APPLICATION NO.	FILING DATE	FIRST NAMED INVENTOR	ATTORNEY DOCKET NO.	CONFIRMATION NO.
10/584,276	05/21/2007	Robert Cudini	CUDI3001 /FJD	4085
23364 BACON & TH	7590 07/02/200 OMAS, PLLC	EXAMINER		
625 SLATERS LANE			DEVITO, ALEX T	
FOURTH FLOOR ALEXANDRIA, VA 22314-1176			ART UNIT	PAPER NUMBER
			2856	
			MAIL DATE	DELIVERY MODE
			07/02/2009	PAPER

Application No.	Applicant(s)				
	10/584,276	CUDINI ET AL.				
Office Action Summary	Examiner	Art Unit				
	ALEX DEVITO	2856				
The MAILING DATE of this communication appears on the cover sheet with the correspondence address Period for Reply						
A SHORTENED STATUTORY PERIOD FOR REPLY IS SET TO EXPIRE 3 MONTH(S) OR THIRTY (30) DAYS, WHICHEVER IS LONGER, FROM THE MAILING DATE OF THIS COMMUNICATION.  - Extensions of time may be available under the provisions of 37 CFR 1.136(a). In no event, however, may a reply be timely filed after SIX (6) MONTHS from the mailing date of this communication.  - If NO period for reply is specified above, the maximum statutory period will apply and will expire SIX (6) MONTHS from the mailing date of this communication.  - Failure to reply within the set or extended period for reply will, by statute, cause

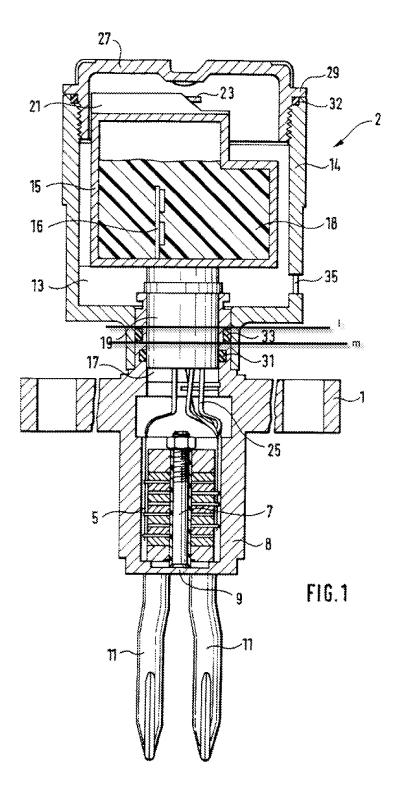
With respect to claim 28, the combination of Dreyer and Frick disclose the measuring device as claimed in claim 25 wherein: said seal [33] has on its outside, contacting the side wall of said connecting compartment, two sealing lips extending essentially in parallel with one another (see annotated Dreyer's figure 1 below).

With respect to claim 29, the combination of Dreyer and Frick disclose the measuring device as claimed in claim 27 wherein: said seal [33] is so arranged in said connecting compartment that the two sealing lips extend essentially in parallel with said gap in the side wall of said connecting compartment (see annotated Dreyer's figure 1 below and column 3, lines 52-61).

extends essentially between the sealing lips of the seal (see annotated Dreyer's figure 1 below and column 3, lines 52-61).

Note sealing lips touching lines I and m are parallel.

FIG. 1

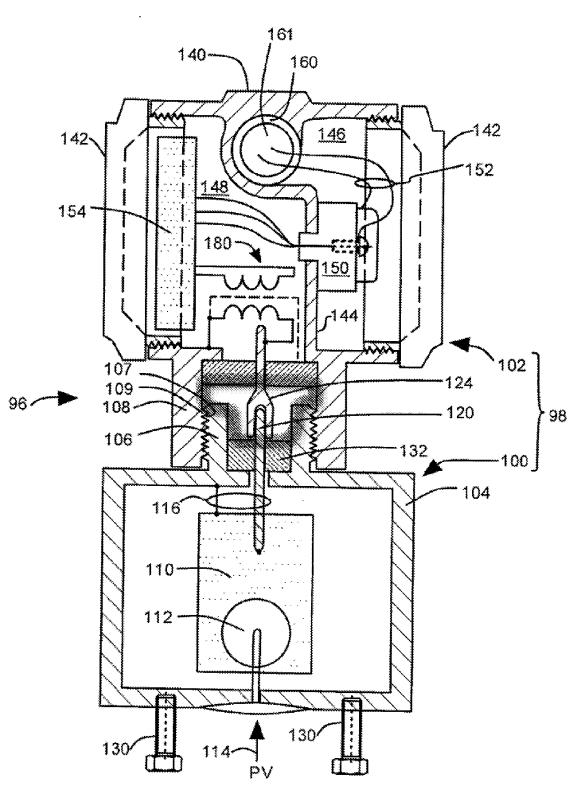
With respect to Claim 21, the combination of Dreyer and Frick disclose the measuring device as claimed in claim 20 wherein: the combination of Dreyer and Frick disclose all the claimed limitations of claim 20 above and also disclose that both said plug elements and said socket elements protrude into said connecting compartment (see annotated figure 1 of Frick below).

Note the highlighted connecting compartment region in which both 120 and 124 protrude into.

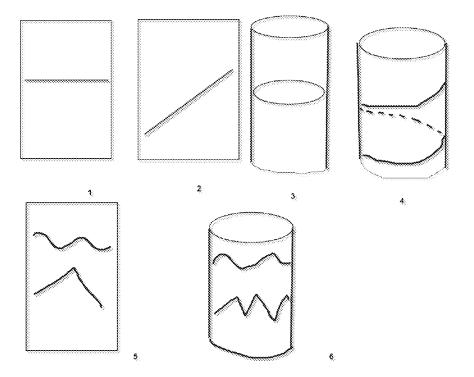
3. Applicant's arguments filed 6/15/09 have been fully considered but they are not persuasive. The examiner disagrees with the assertion put forth in paragraphs 3 and 4 of page 1 in the remarks. The examiner finds that the thread-fittings due have essentially straight grooves and projections. The concepts need not be mutually exclusive. Please refer to the examiner made drawings before for the following rebuttals.

The examiner finds the line in rectangle 1 to be straight. The line in rectangle 2 is also straight, even though it is at an angle. The examiner finds a similar reason to hold true for lines on a cylinder as seen in 3 and 4 above. Assume figure 4 is a helical design and ignore any inaccuracies due to lack of drawing skills. The examiner finds the lines

in figures 5 and 6 to not qualify for being essentially straight. If the thread-fittings were not essentially straight, they would not screw into each other. In regard to neither of the prior arts hinting at the purpose being to simplify mounting modules together and to assure the mounting is in a correct way, the applicant is correct. Note that the purpose of an apparatus is not of patentable merit as identically claimed apparatuses should tautologically be sufficient to fulfill the same purpose. In regard to mounting in the correct way, this is not listed anywhere in the claims, but if the applicant is referring to claim 24, then the threading to determine a unique installation position as seen with the rejection of claim 24 above.
